Courtyard enclosure study · closing the conditioned house around the open courtyard · Taif / Palm House V7.1

Design review Y-01 (critical) · 30 Oct 2026 · the windows follow `docs/DESIGN_LANGUAGE.md` (black steel, divided lites)

DECIDED: option A (owner, 30 Oct 2026, applied in V7.0): the projection 1.55 m, B3 / R11 / C21–C23 at x 5.80, W1 / W2 / W3 as in § 2. The "now" column below is the V6.3 state (edge x 5.60), kept as the record of the comparison.

Plans of the gallery strip, first floor · now / A / B · the sky opening and the void · about 1:115 on A4

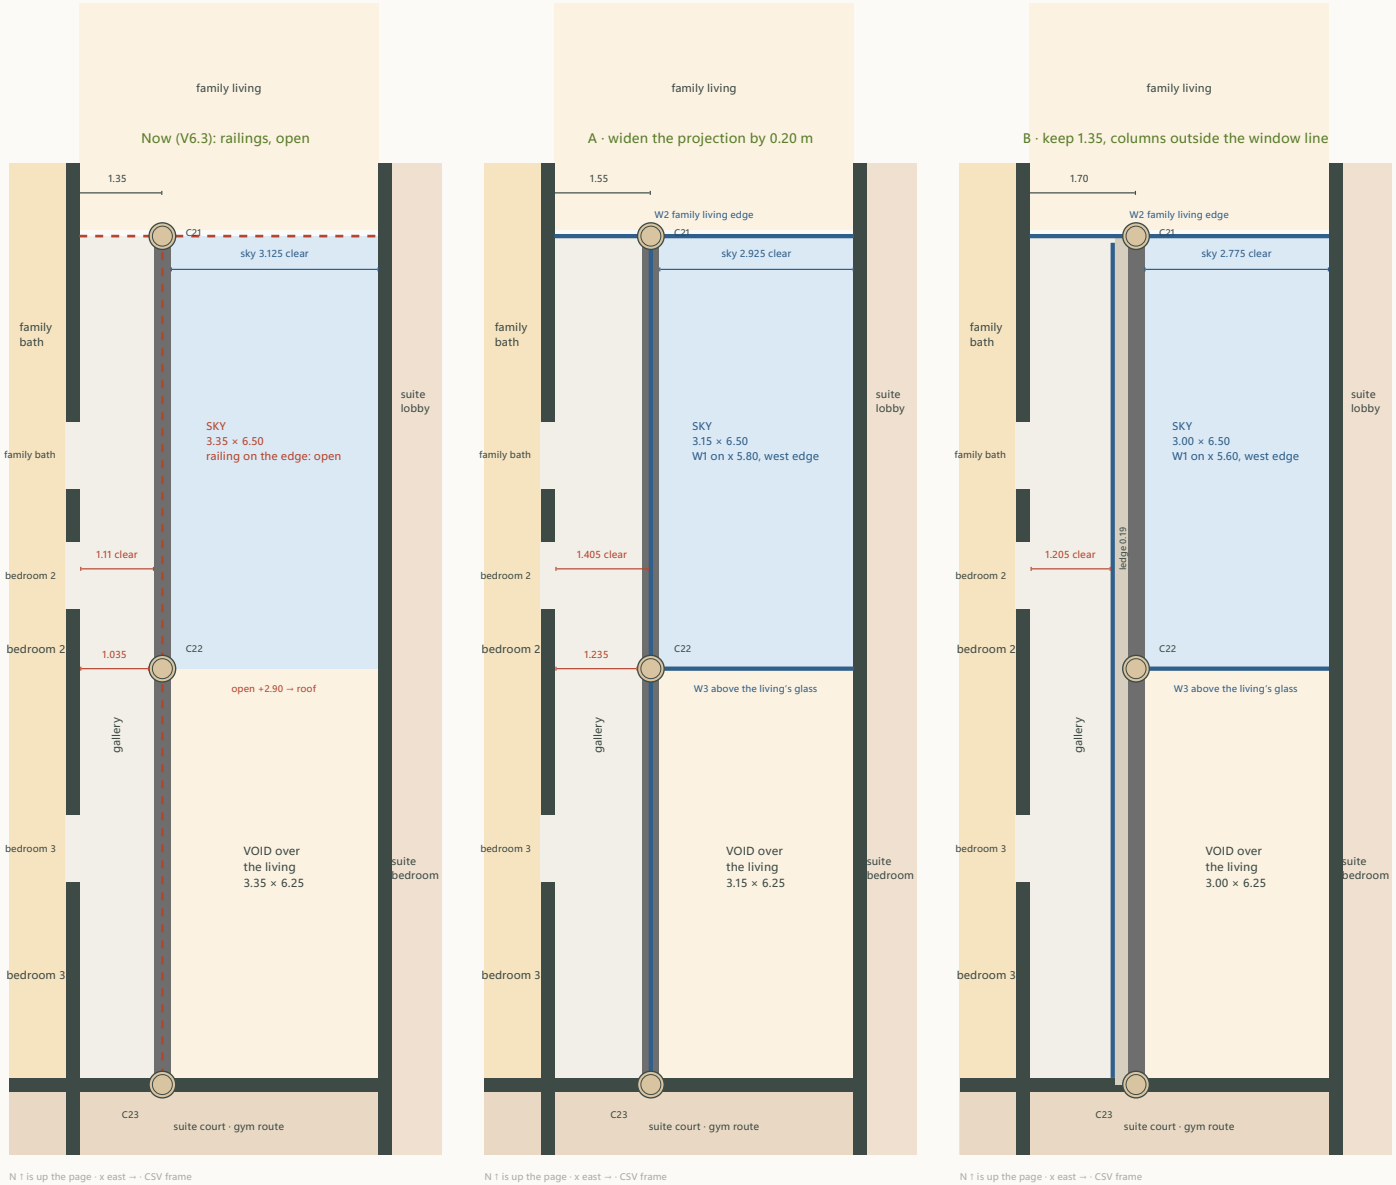
Today the gallery is 1.11 m clear between the rooms' finished wall face (x 4.365) and the upstand of B3, and 1.035 m at the three stone column sleeves (Ø0.4). A window on the line changes little by itself; the columns are the problem. Two ways to reach 1.20 m:

Dark: walls and the edge beam B3 (0.25 wide, upturned 0.30 above the slab). Blue lines: the new steel windows W1 / W2 / W3; red dashed: the open railings of today. Columns: the stone sleeve Ø0.4 round the Ø0.3 core. In B the beam and the columns leave the window line and a 0.19 m ledge lies between the glass and the beam (capped in stone, falling to the courtyard). The gallery doors are the V6.3 1.00 m openings.

4 · Recommendation: A **A** keeps everything on one line: the beam, the columns, the window and the railing base are the same element, the gallery is 1.405 m clear and 1.235 m at the columns, the sky loses 6 % of its area and stays 3.15 m wide on axes. **B** reaches 1.20 m with no margin (1.205 m), narrows the sky more (3 m: the beam and the roof edge must follow the columns), and adds a 0.35 m ledge outside the glass that must be waterproofed, capped and kept clean; its one real gain, free-standing columns in front of a glass wall, is a stronger colonnade image. If the owner wants that image, B is buildable; otherwise A. In both, the two-storey columns, the upturned B3 and R11 stay as decided (X8); only their x changes. **Study checks passed** (7)

Sections through the courtyard (y ≈ 10, looking north) · A and B · about 1:105 on A4

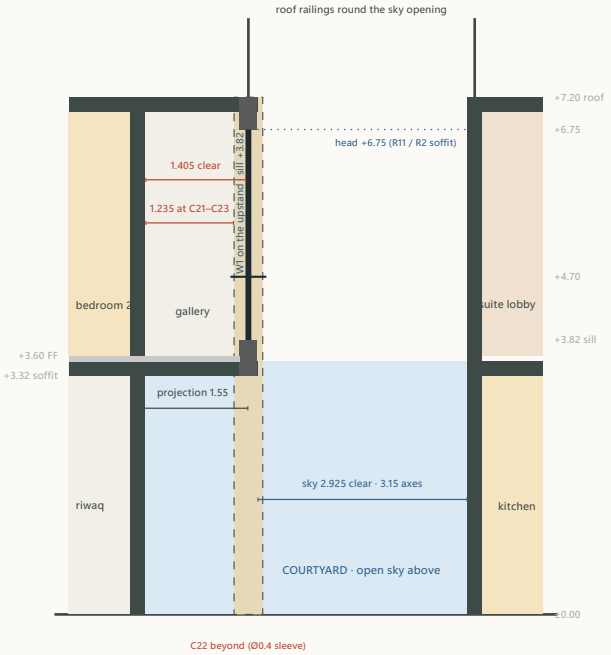
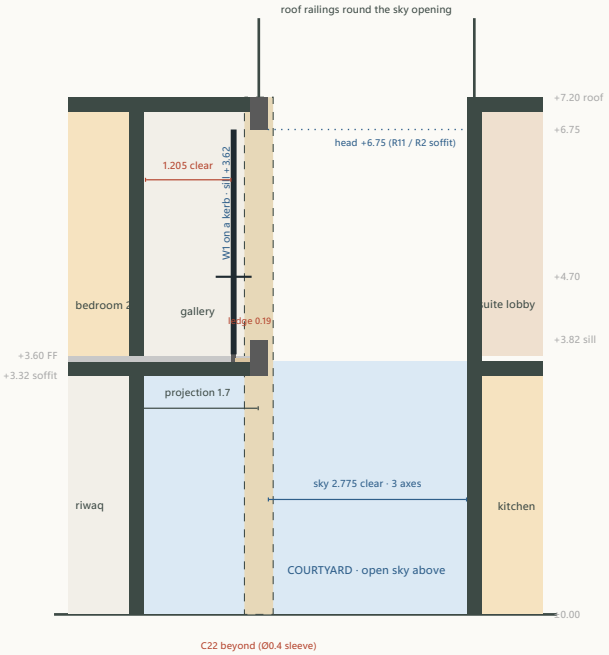
Dark: walls, slabs, the roof; grey: the upturned edge beam B3 (0.25 × 0.50 total, 0.30 above the slab) and the roof edge beam R11 above it; the dashed column is C22 (y 13.0) beyond the cut. W1 (heavy black line) sits on the upstand (A) or on a 0.10 m kerb inboard of it with a stone-capped ledge outside (B); its guarding transom at +4.70, its head at +6.75 under R11.

- **A:** B3, R11 and C21–C23 move 0.20 m east to x 5.8 the projection slab bay becomes 1.55 m (slabs-ff row "the projection"), the roof strip over the gallery 1.55 m (slabs-roof); C22 stays the pier in the living's courtyard glass (now at x 5.8), C21 in the women's majlis glass, C23 in the living's south wall; the spans (6.5 / 6.25) are unchanged, R2's west end lands on C22 at x 5.8. The sky opening is 3.15 × 6.5 m.

- **B:** B3, R11 and C21–C23 move 0.35 m east to x 5.95 the slab bay becomes 1.7 m with the window line 0.35 m inboard of the beam on a 0.10 m kerb; the ledge between the kerb and the upstand is waterproofed and capped (stone, falling out). The columns stand free in the courtyard and in the void: C22 is a free column in the living's courtyard glass line, 0.35 m in front of the upper window W3 (W3 then runs behind it, from the W1 line at x 5.6 to the kitchen wall, 3.25 m). Alternative B2 (not recommended): B3 stays at x 5.6 and reaches the columns at x 5.95 on short corbels; two lines of concrete for one edge.

W1 · the gallery line seen from the courtyard and the void (looking west) · option A · 1:70 on A4

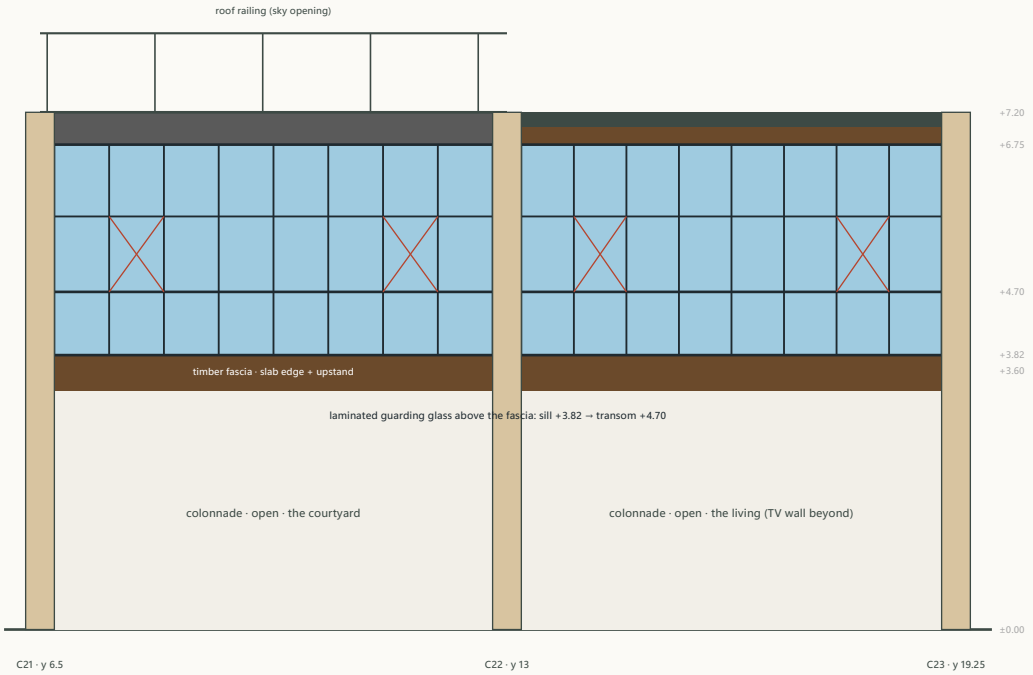
V7.1 (owner, 31 Oct 2026): semicircular heads and the courtyard arcade. Every enclosure window gets a semicircular (Roman) arched head in black steel with divided lites, the arched head fixed, the rectangular part below with the operable lites; the sill and the guarding transom (+4.70) as in § 2. **W1:** six arched windows 1.60 m wide on the gallery edge, three per column bay, sill +3.82, springing +5.80, crown +6.60, 0.15 m of wall below the R11 / R2 soffit (+6.75): in the courtyard bay they stand over the three bays of the new arcade (y 6.783–8.383, 8.950–10.550, 11.117–12.717), in the void bay on three equal bays (13.242–14.842, 15.325–16.925, 17.408–19.008); the four casements sit in the lower parts. **W2:** two arched windows 1.30 m wide east of C21 (x 6.00–7.30 and 7.55–8.85), floor to the crown +6.60, springing +5.95; the strip x 4.25–5.80 of that edge is the family living's opening to the gallery's north end, no window. **W3:** one arched window 2.80 m wide (the whole space between C22's stone sleeve and the east wall; the brief said ≈ 3.0) over the living's courtyard glass, +3.32 to the crown +6.60, springing +5.20, the two motorised tilt lites in its lower part; 0.15 m of wall to the R2 soffit. **The arcade:** in the courtyard bay only, two slender honey-stone columns Ø0.25 on x 5.80 at y 8.667 and 10.833 (three equal bays of 2.167 m on axes) with three semicircular arch plates under the projection's soffit (+3.27): spans 1.84 / 1.92 / 1.84 m between the sleeves, springing +2.35 / +2.31 / +2.35, crown +3.27; decorative unless the engineer uses the columns (`studies/structure.typ` X18); the living bay keeps no arches. The columns stand 0.78 m clear of the sunken seating's west edge, 1.36 m clear of the riwaq door's swing line, 1.33 m from the riwaq glass face; the malqaf outlet is on the east wall. The courtyard reads as a two-tier arcade: three arches below, three arched windows above.

black steel, divided lites ≈ 0.75 wide · transoms at +4.70 (guarding) and +5.75 · red X = inward side-hung casements, two per bay (night mode, cleaning) · about 35.01 m² of glass · A · widen the projection by 0.20 m
